EDINBURG CISD

ADDENDUM 3
CSP 23-02
UTRGV-EDINBURG CISD COLLEGIATE HIGH SCHOOL
October 3, 2022

This addendum is issued for the purpose of modifying the plans and specifications for the *UTRG/EDINBURG CISD COLLEGIATE HIGH SCHOOL*.

A2.10

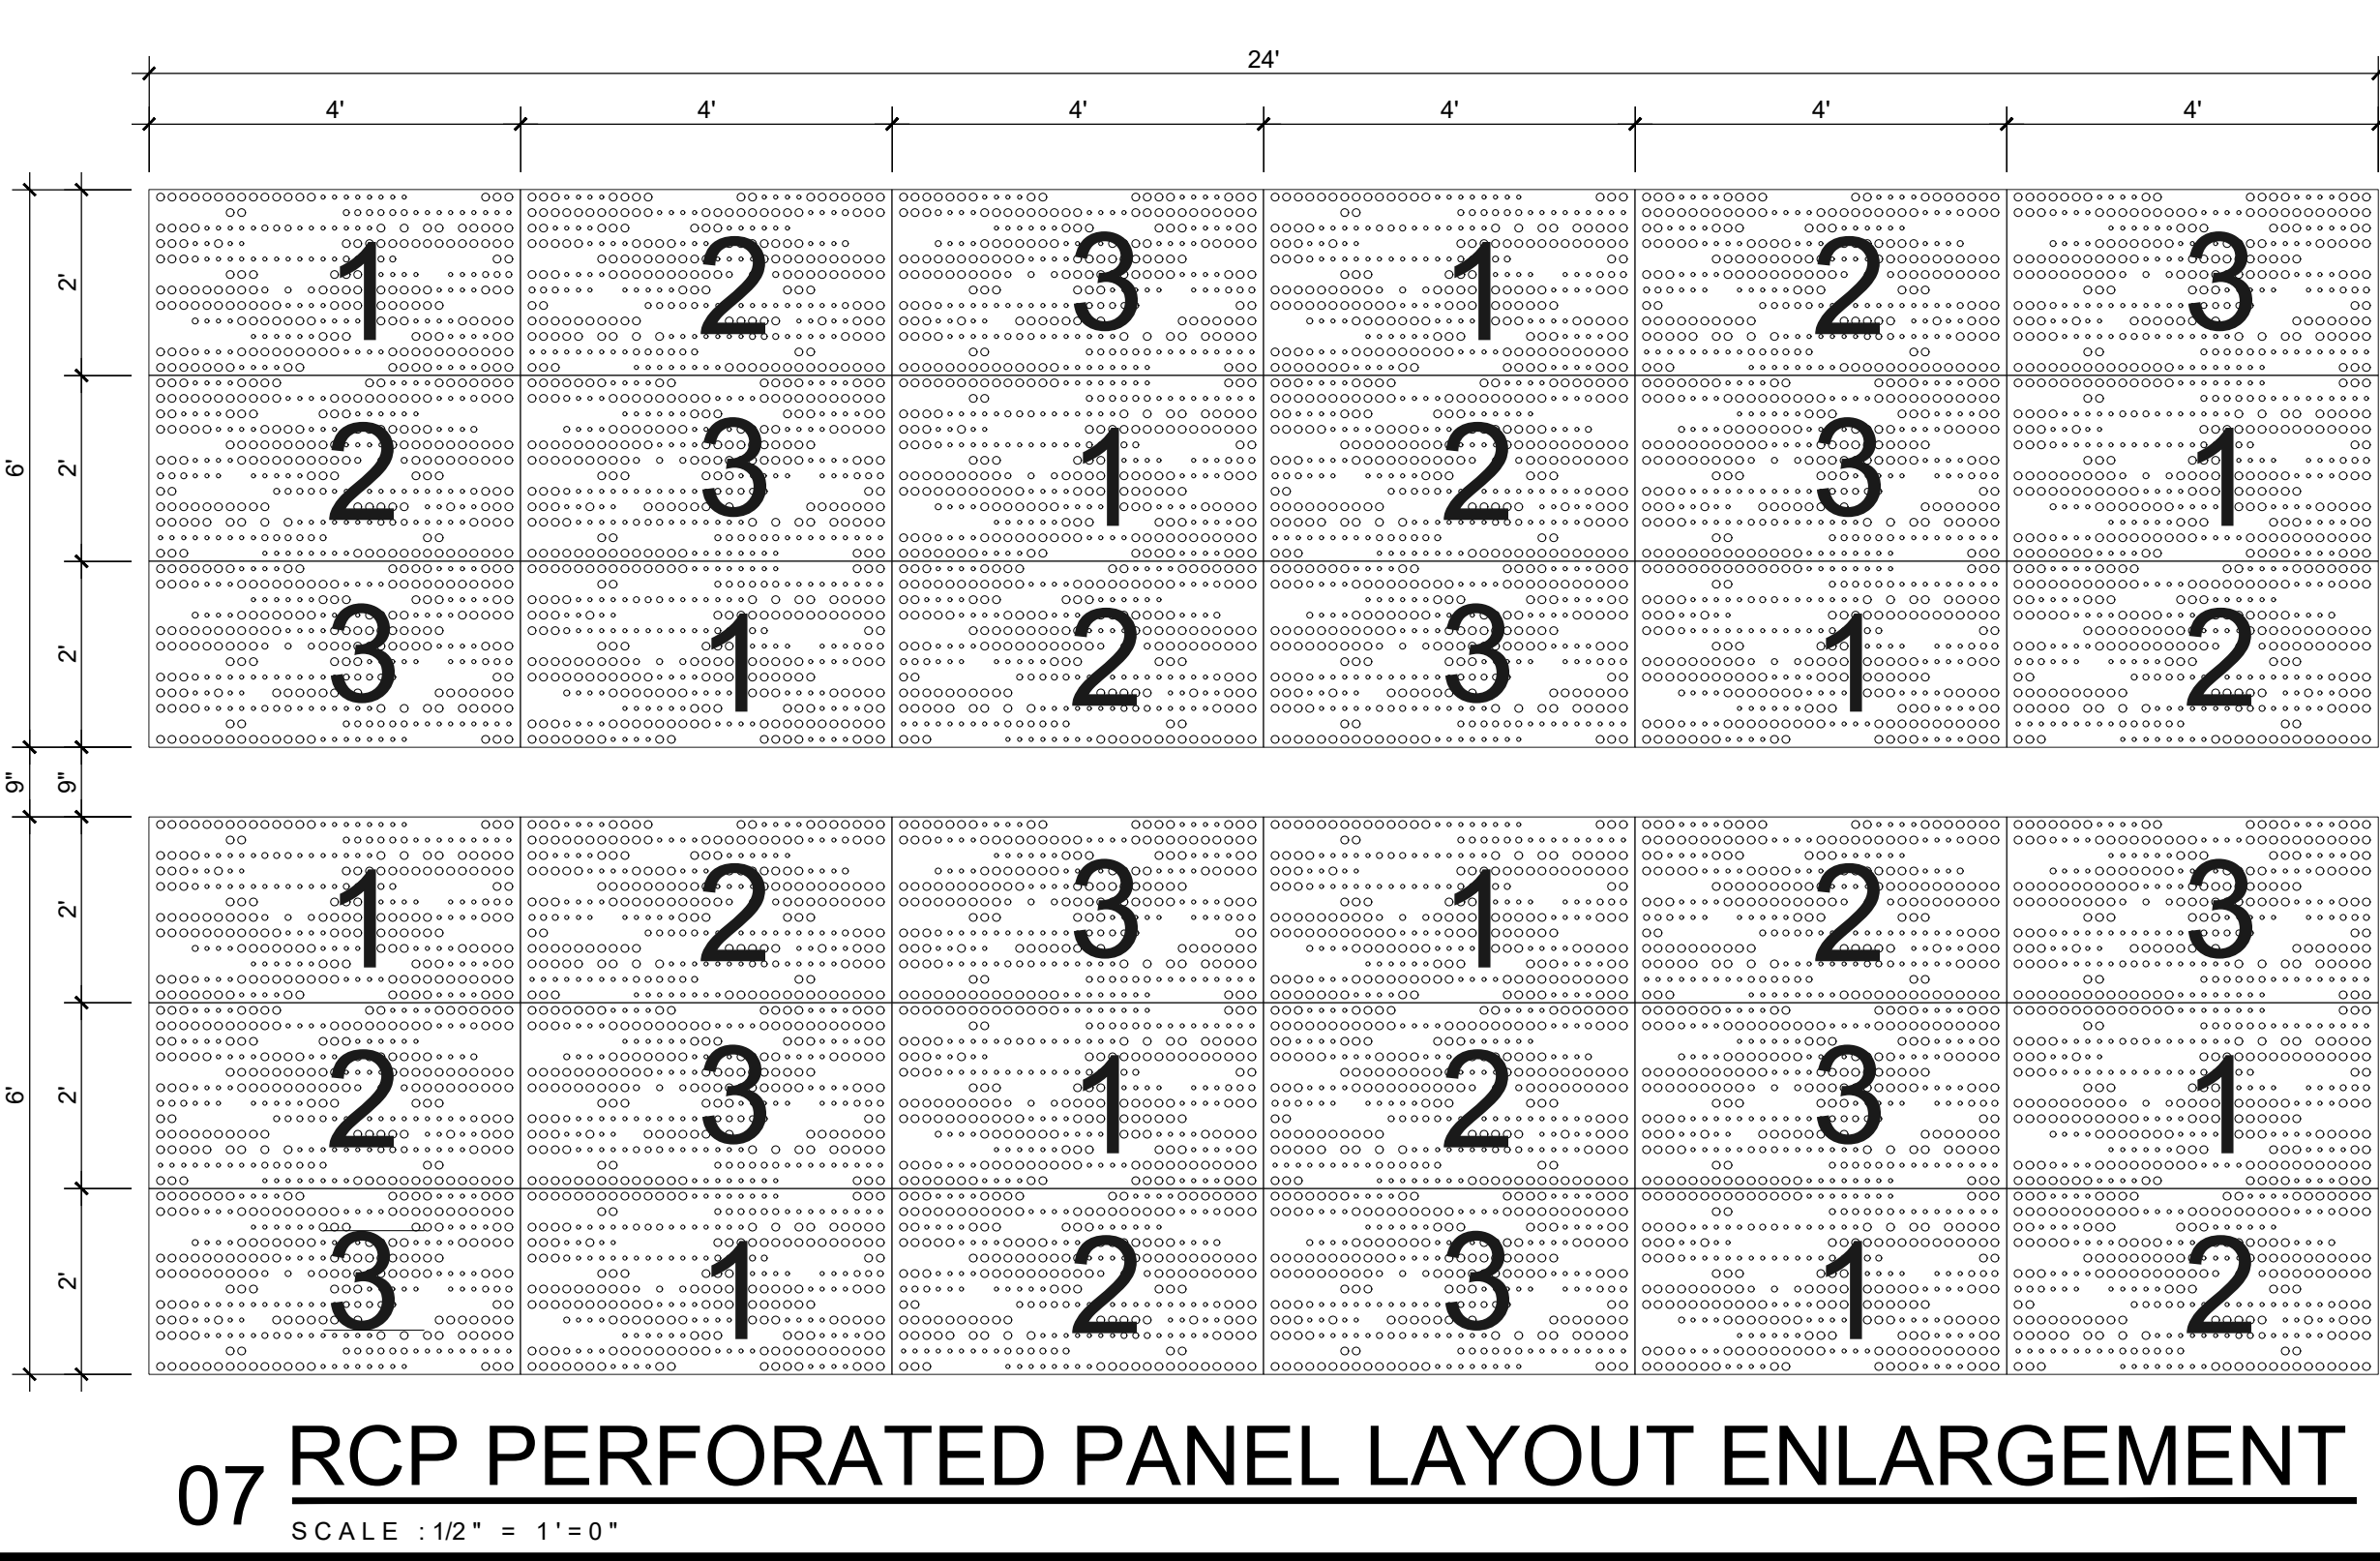
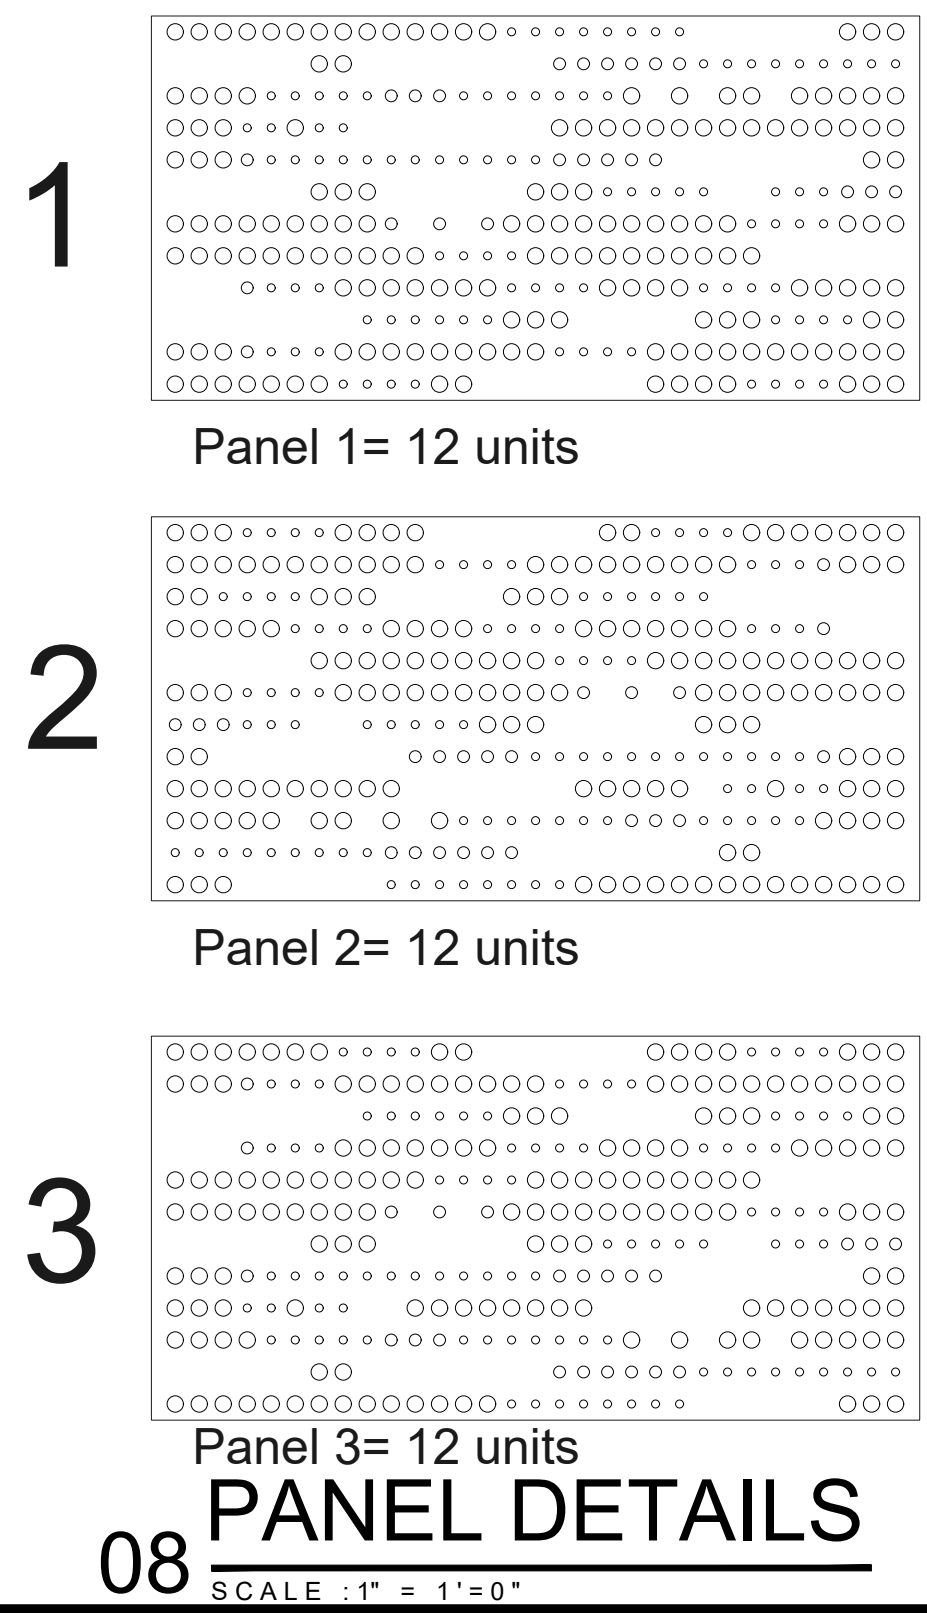
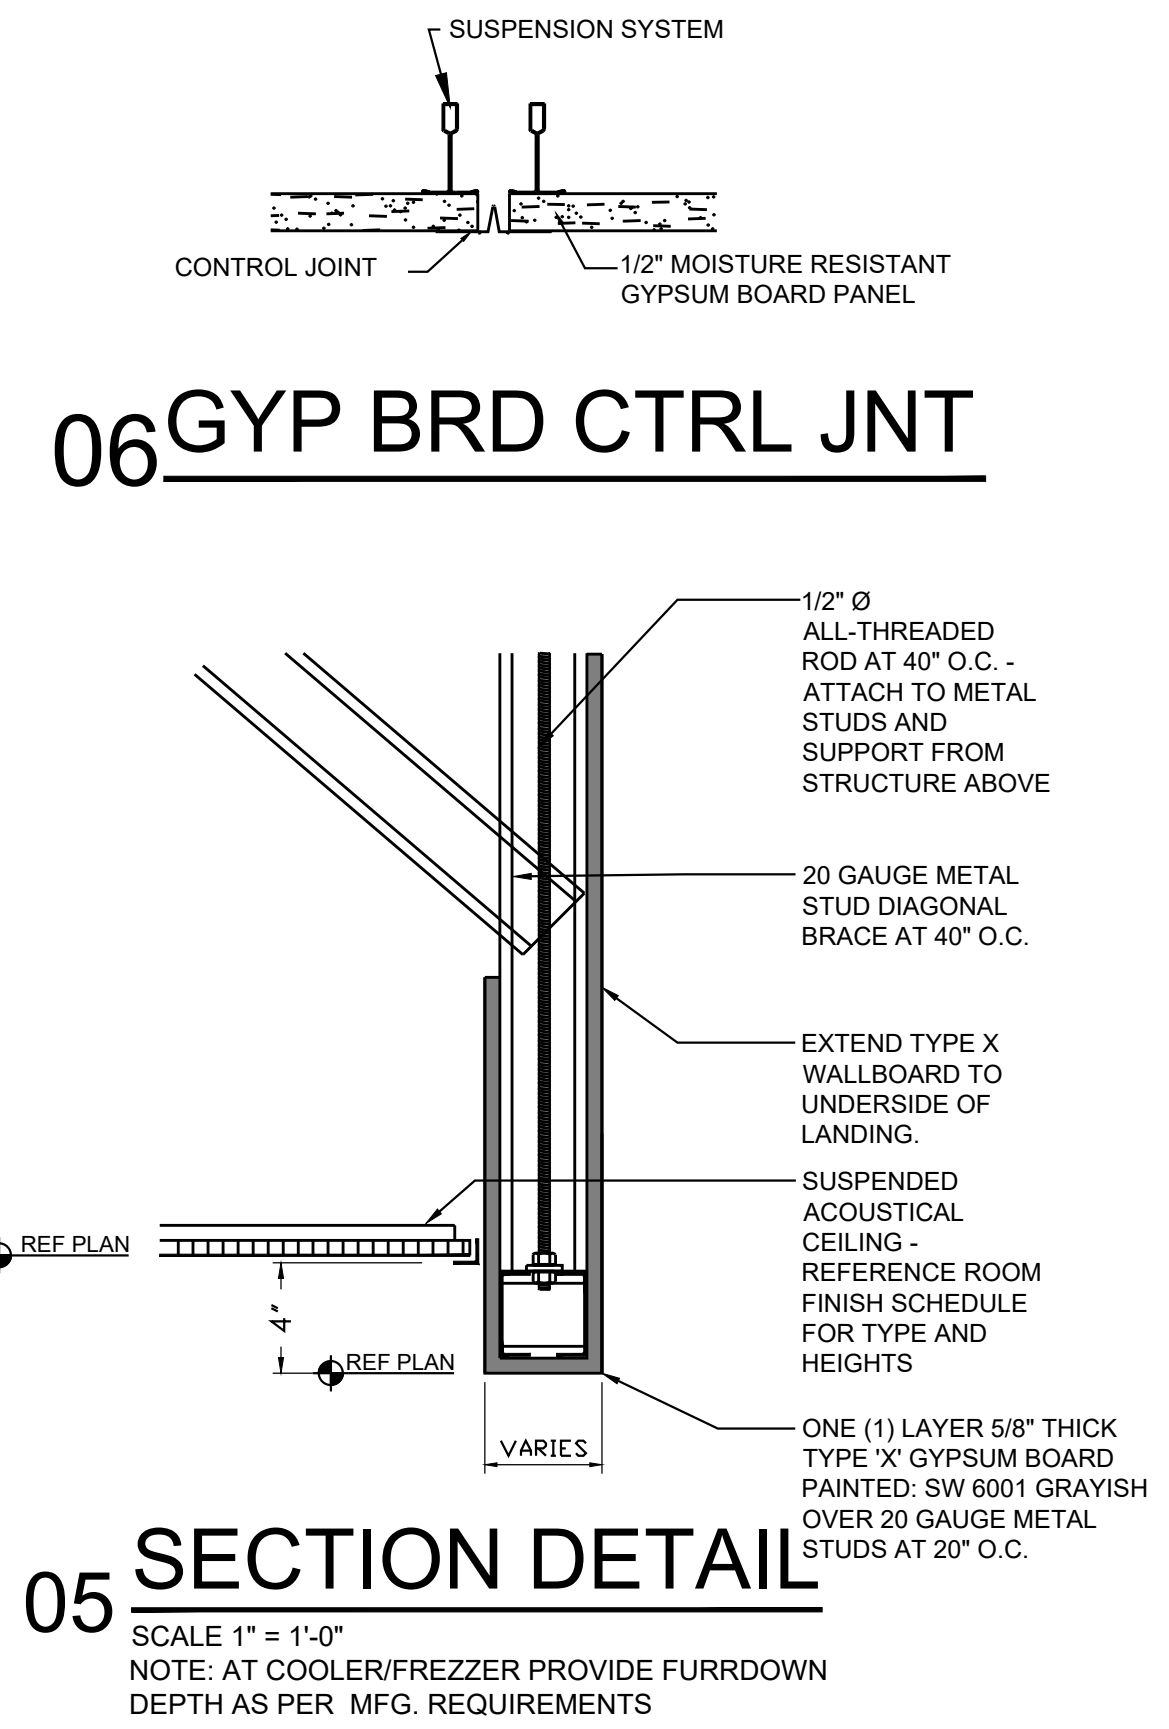
- c. Revise note for USG Celebration Torsion Spring System in lieu of Armstrong Metal Works Torsion Spring.
8. Sheet A2.10

- a. Revise note for USG True Wood Panels in lieu of Armstrong Acoustical Vertical Wall Panel.
 - b. Revise note for Vertical Baffels by Chroma Collections.com in lieu of Armstrong Metal Works.
 - c. Clarification at suspended wood clouds at Collaboration Space 170. Wood Clouds to be set at 30'-0" from first floor finish floor.
9. Sheet A2.11
- d. Revise note for USG True Wood Panels in lieu of Armstrong Acoustical Vertical Wall Panel.
10. Sheet A3.01
- a. Add Operable Partition
11. Sheet A3.15, A3.16, A3.17, A3.18 and A3.19
- a. Revisions to Stairs
12. Sheet A5.01
- a. Revisions to West Elevation windows and accent brick to accommodate operable partition.
